## ADDENDUM No. 2

RFP No. 23-25

### Earhart Road Improvements Project

CITY OF ANN ARBOR - PUBLIC SERVICES - ENGINEERING  
**EARHART ROAD IMPROVEMENTS (GEDDES - US23)**  
 SCALE: N/A  
 DRAWING No. 2021023-8  
 SHEET No. 8 OF 85  
 SIDEWALK RETAINING WALL DETAILS

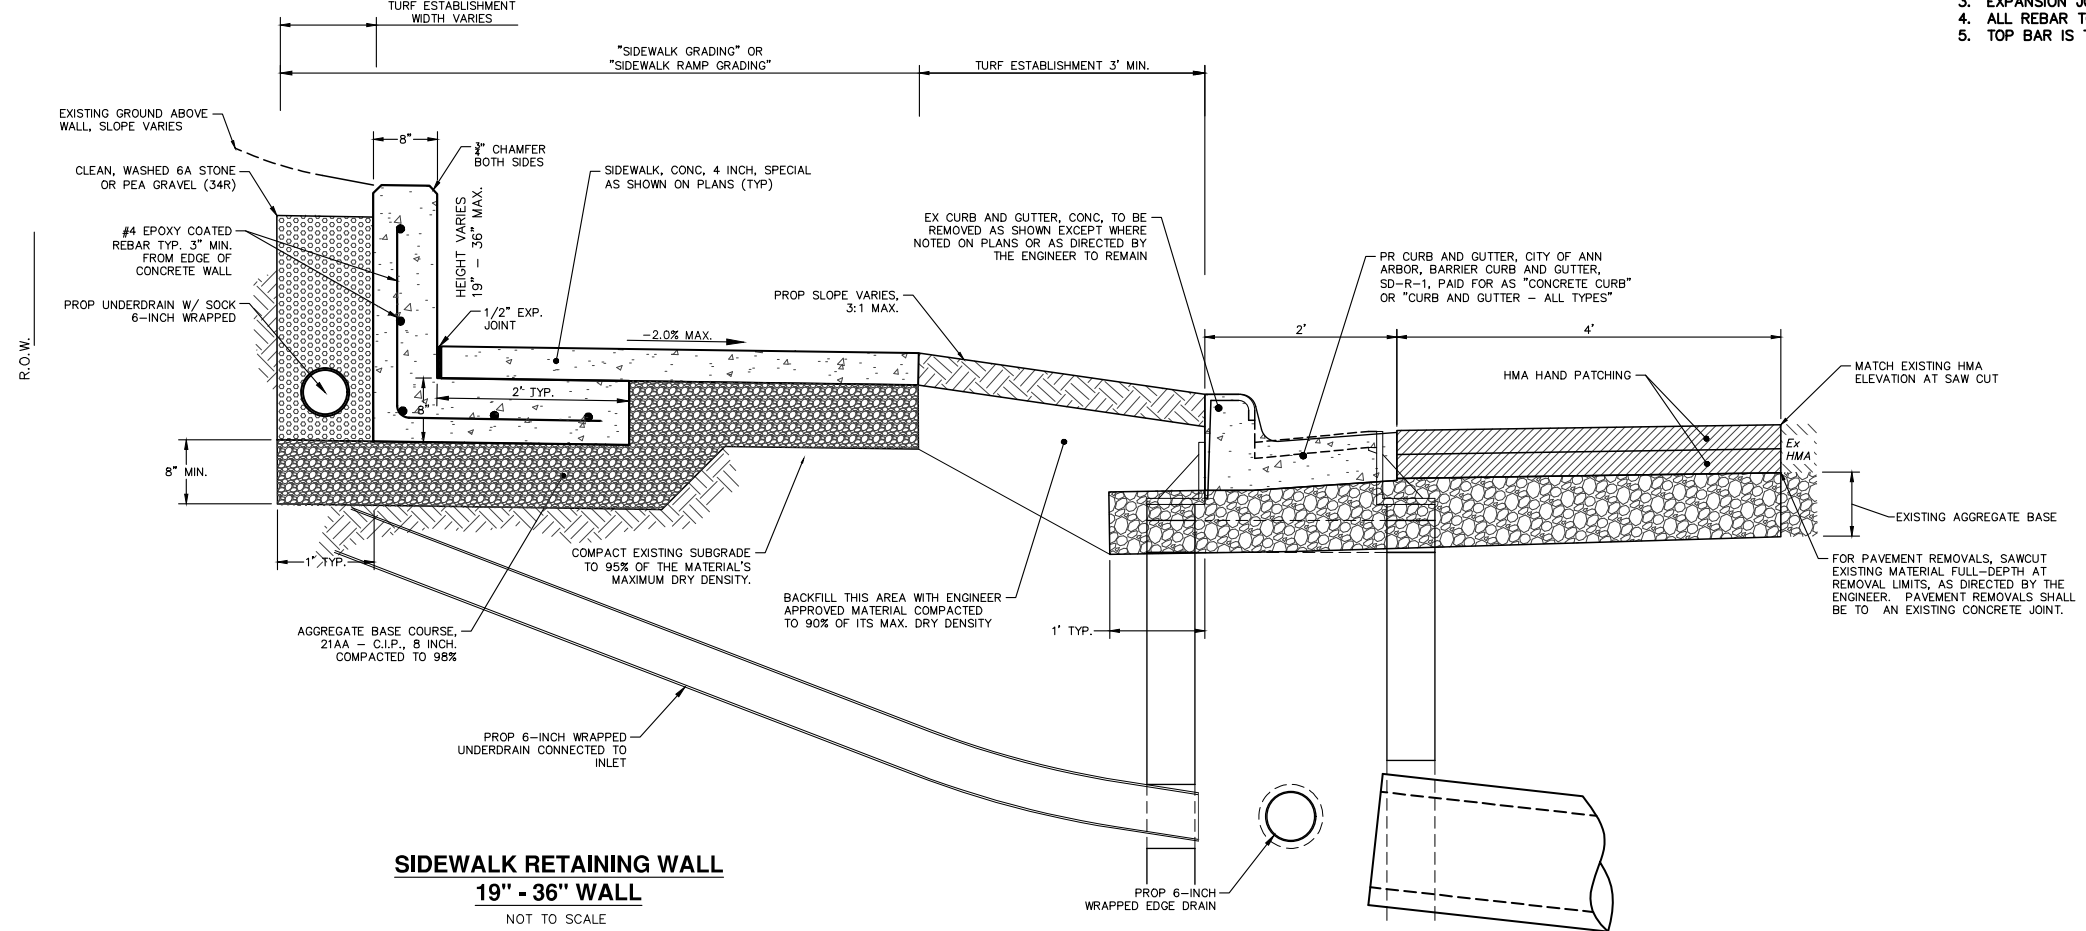
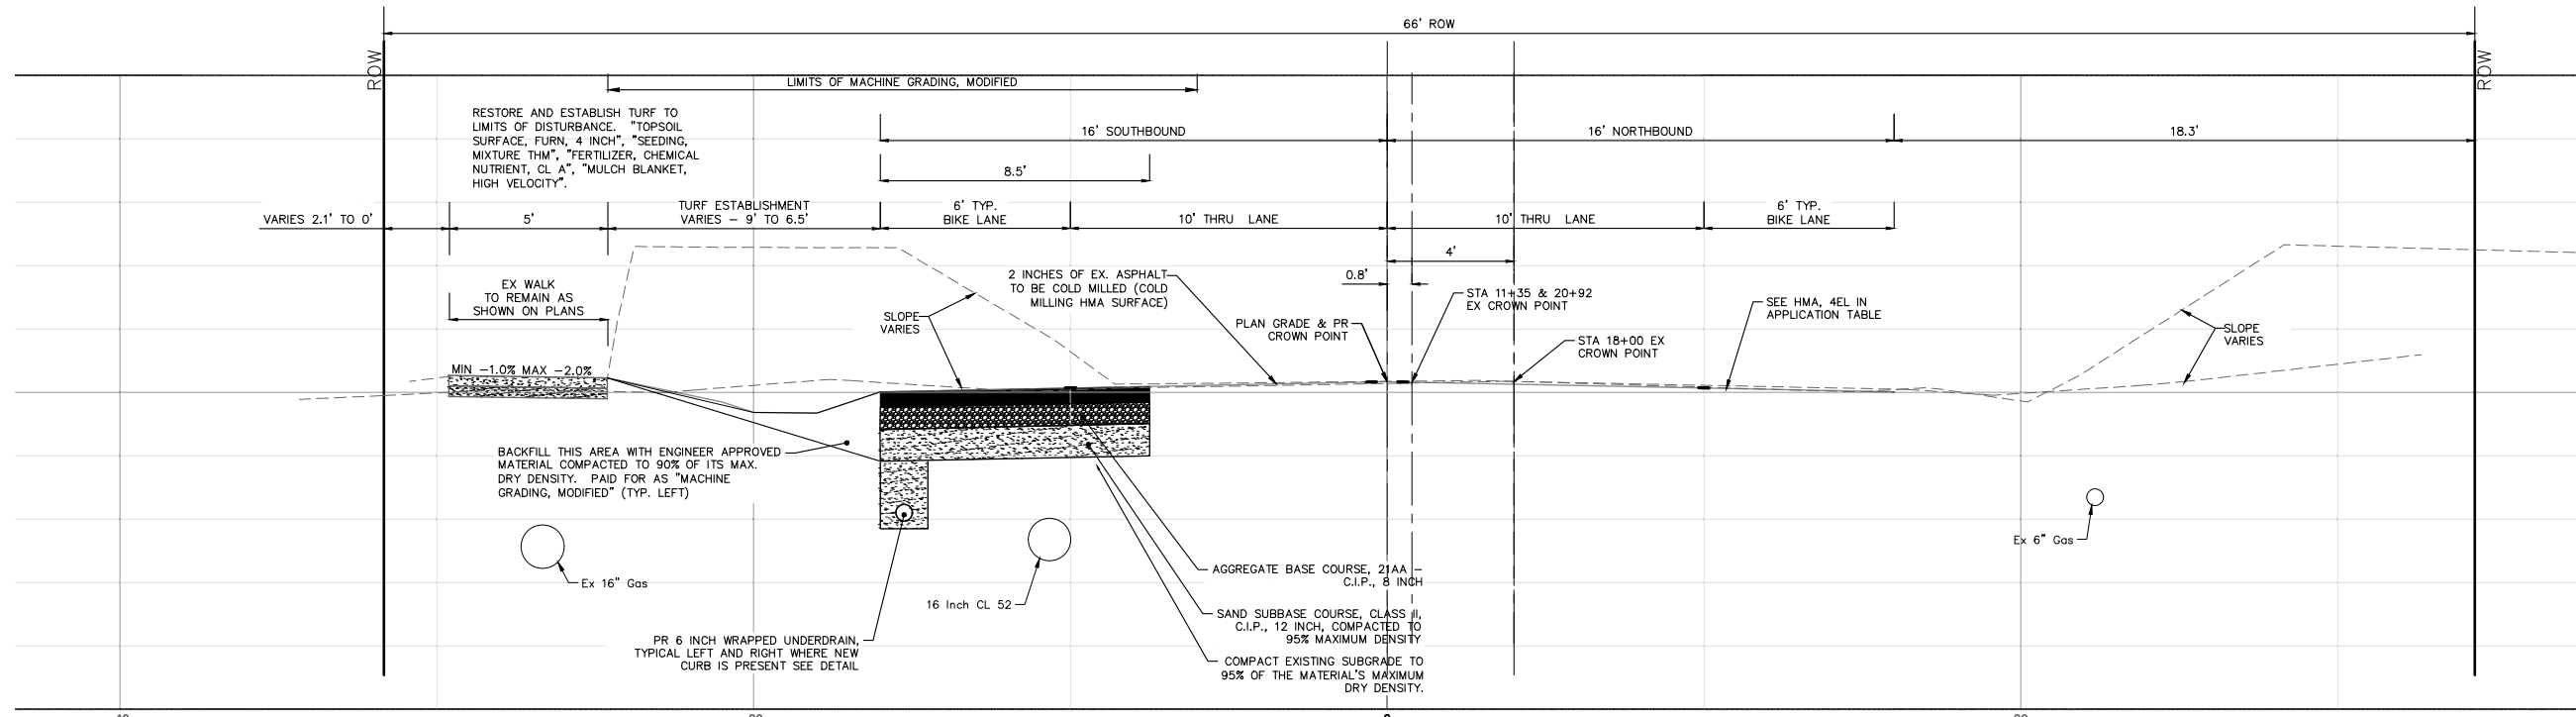
<b>Section/Page(s)</b>	<b>Change</b>
Plan Sheets 7	Revised Electrical Details
New Plan Sheet 8	Include sidewalk retaining wall typical cross-sections
Plan Sheets 16-25	Revised Maintenance of Traffic Plan to use Temp paint pavement markings vs Temporary Tape.
Plan Sheet 36	Revised Electrical Call Outs
Plan Sheet 41	Revised to include retaining wall in plan view

SHEET No. **46 OF 85**

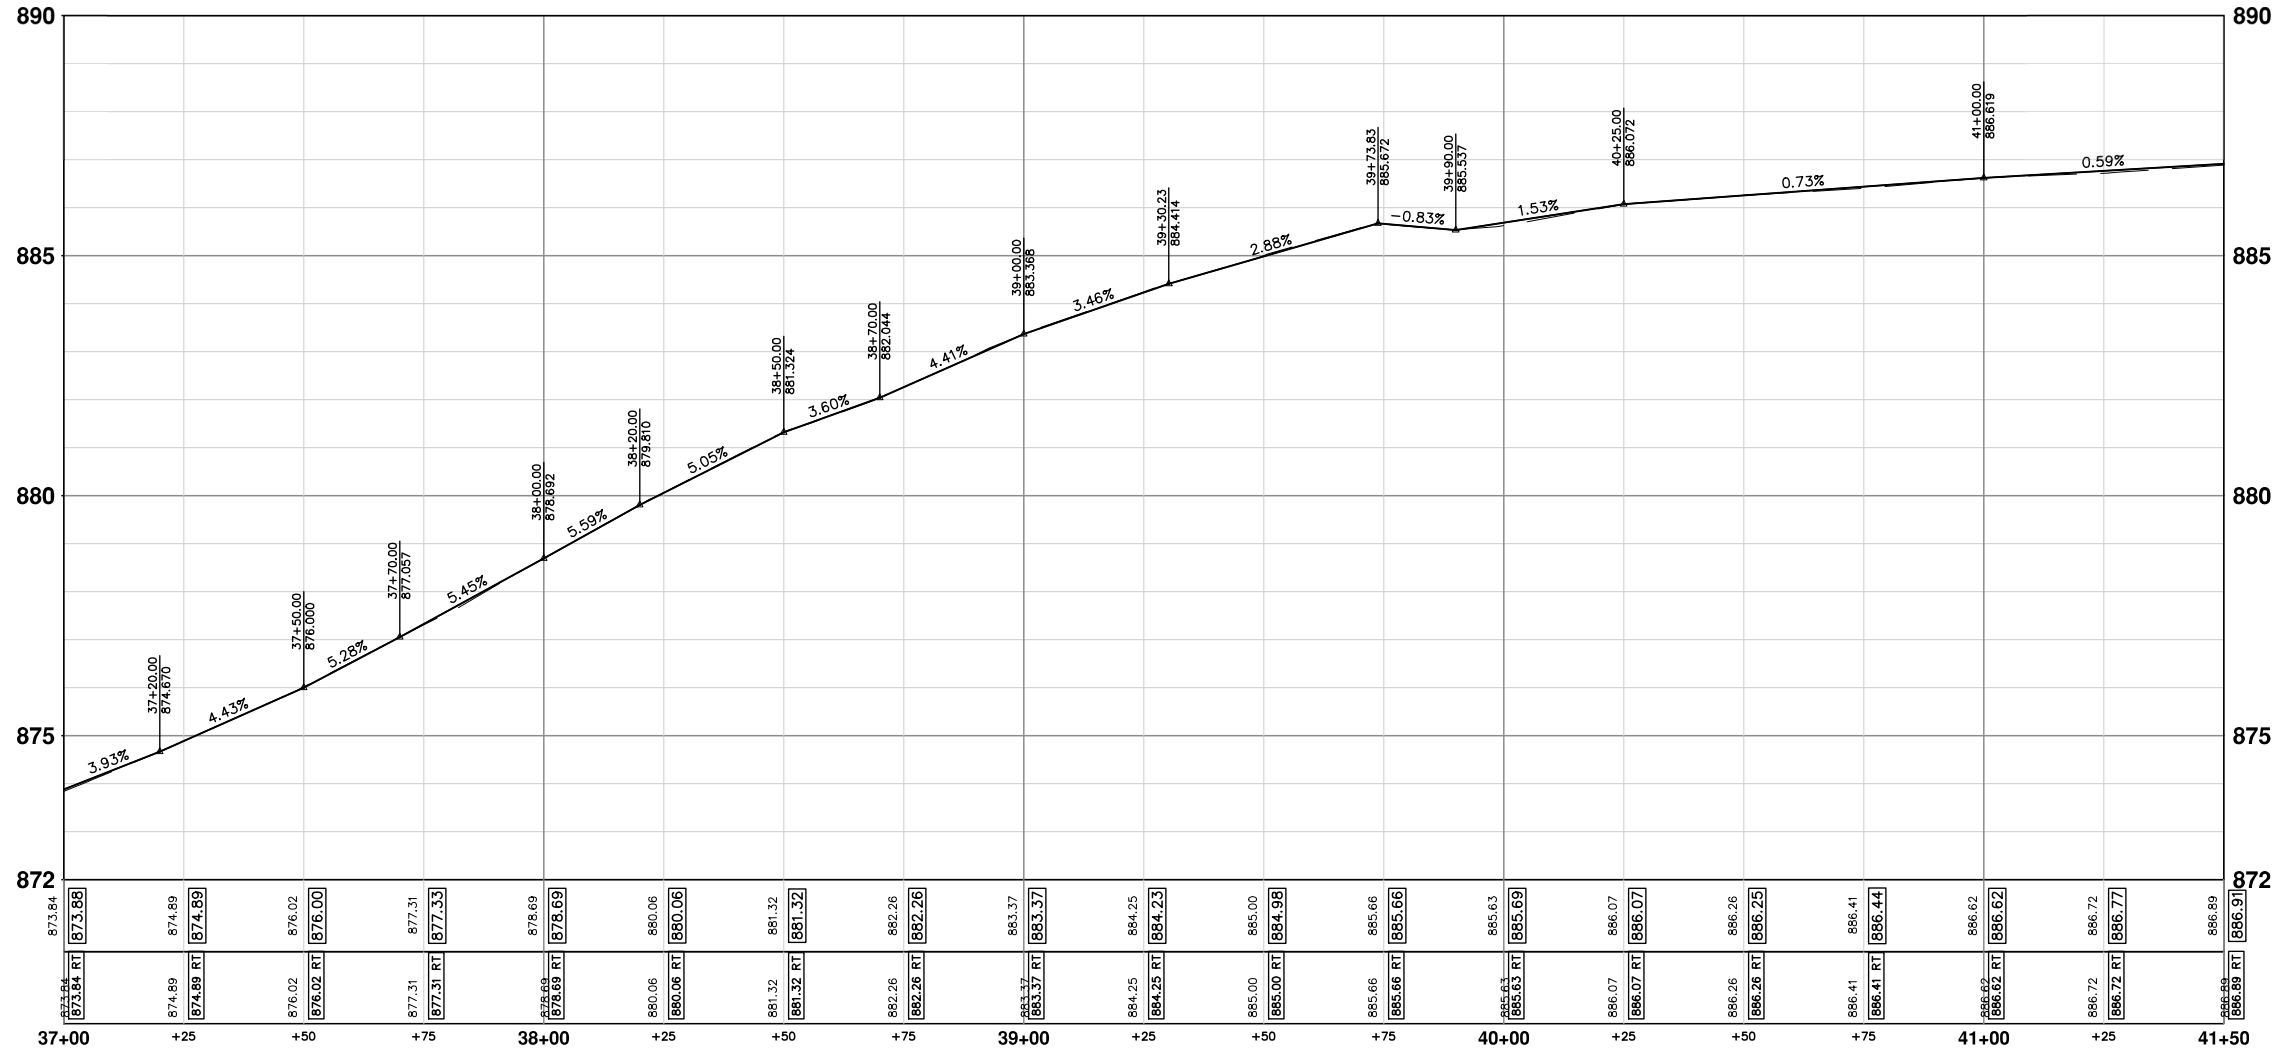
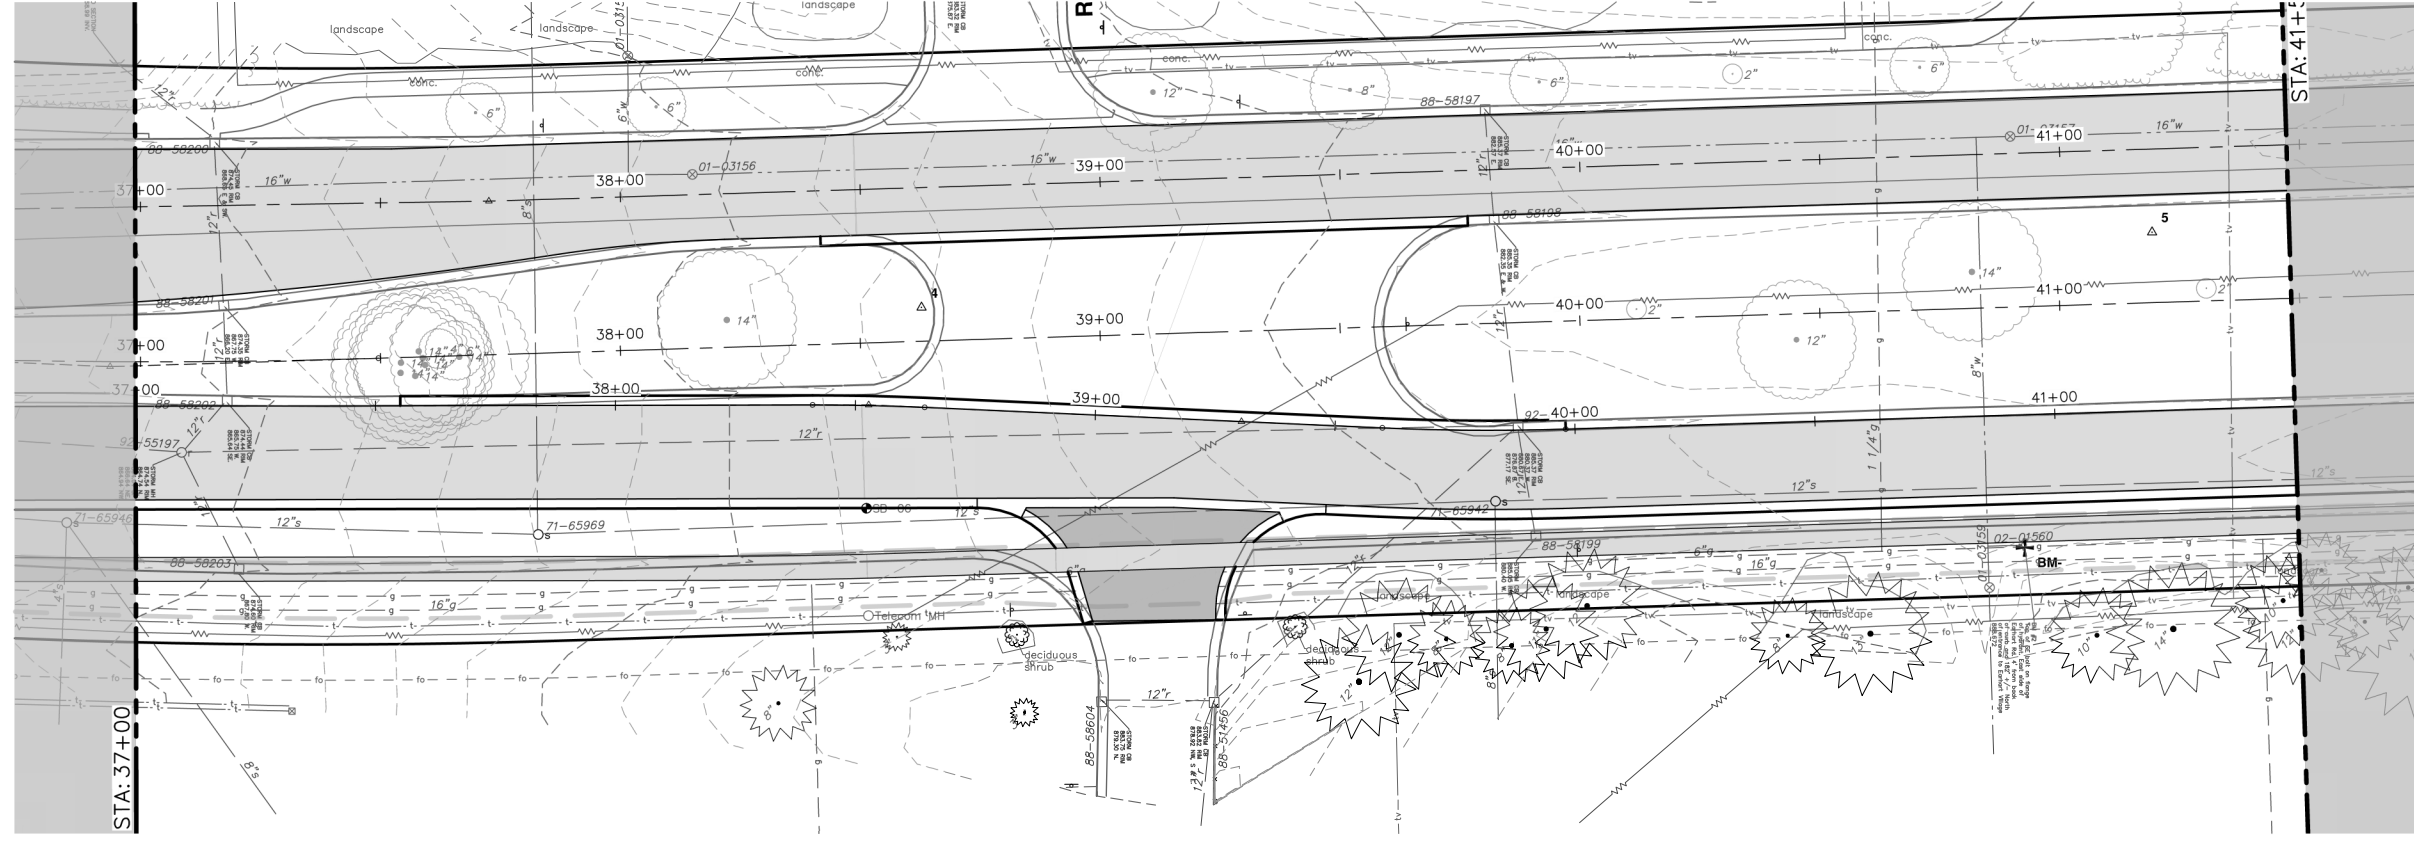
New Plan Sheets 46-50	Include plan and profile of new curb line along lane narrowing.
New Plan Sheets 55-59	Include plan and profile sheets for new sidewalk.
Plan Sheets 61-63	Revised to include Detail Grades
Plan Sheets 66-74	Revised pavement marking plans to reflect use of Cold Plastic Bike Symbols and arrows.
Plan Sheet 75	Revised cross sections to include sidewalk retaining wall.
Replace Plans Sheets 1-85	Entire plan set is re-issued as addendum.
Wage Decisions Pg 6-7	Heavy MI 20230074 02/03/2023 and Highway MI 20230001 03/17/2023 wage decisions in effect for the project as references documents can be downloaded from Sam.Gov
Bid Form Replace Pages 15-18 with pages 15-18	The bid form has been amended to reflect the modifications of this Addendum No. 2 and other quantity corrections from original contract documents.
Replace Pages DS-1-2	Detail Spec Index, Replace to include new items
Replace Pages DS-26-27	Conduit, Direction Bore
